# Access Compliance Report

## Public Rights-of-Way

Intersection ID: 14846	Main Street: HENLEY_PL	Cross Street: S_KINGS_DR	Location: NE
ADA ID: 19FA4148CC0C	Ramp Type: Perp	Initial Pass/Fail: Fail	Overall Compliance: No
Severity Score: 13.75			
Codes/Mitigation Info/Possible Solution		Field Measurements/Component Compliance

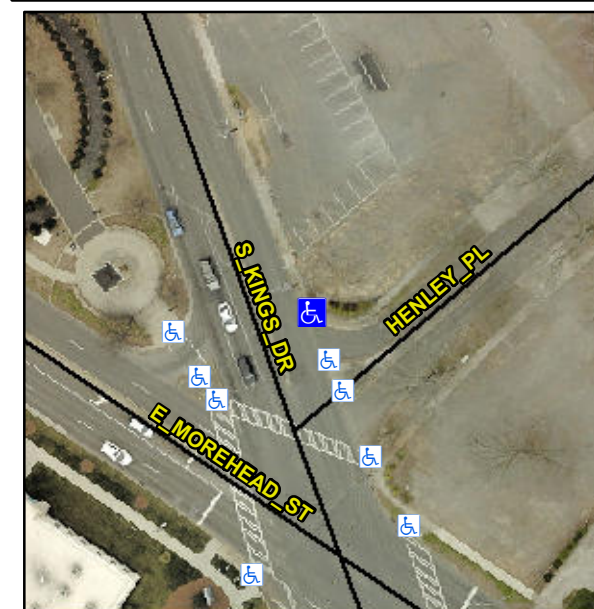
**Not Found, R304.2.2, R304.5.3**

Compliance	Description	Data	Compliance	Description	Data
N/A	Ramp Length (in)	61.5	No	Ramp Slope (%)	8.8
Yes	Ramp Width (in)	48.0	No	Ramp XSlope (%)	3.7
N/A	Flare Type LT	N/A	N/A	Flare Type RT	N/A
N/A	Flare Slope LT (%)	N/A	N/A	Flare Slope RT (%)	N/A
N/A	Flare Traversable LT?	N/A	N/A	Flare Traversable RT?	N/A
N/A	Landing Length (in)	N/A	N/A	DWS Provided?	N/A
N/A	Landing Width (in)	N/A	N/A	DWS Contrast?	N/A
N/A	Landing Slope (%)	N/A	N/A	DWS Length (in)	N/A
N/A	Landing X Slope (%)	N/A	N/A	DWS Full Width?	N/A
N/A	Landing Curb? (Y/N)	N/A	N/A	DWS Offset (in)	N/A
N/A	Shared Landing?	N/A			
N/A	Gutter Ponding?	N/A	N/A	Gutter Slope (%)	N/A
N/A	Gutter Lip Ht (in)	N/A	N/A	Gutter X Slope (%)	N/A
N/A	Painted X Walk1?	No	N/A	Painted X Walk2?	N/A
	X Walk 1 Direction	To S		X Walk 2 Direction	N/A
N/A	X Walk 1 Width (in)	N/A	N/A	X Walk 2 Width (in)	N/A
	X Walk 1 Slope (%)	3.3		X Walk 2 Slope (%)	N/A
	X Walk 1 X Slope (%)	0.5		X Walk 2 X Slope (%)	N/A

**Remove & Replace Entire Ramp.**
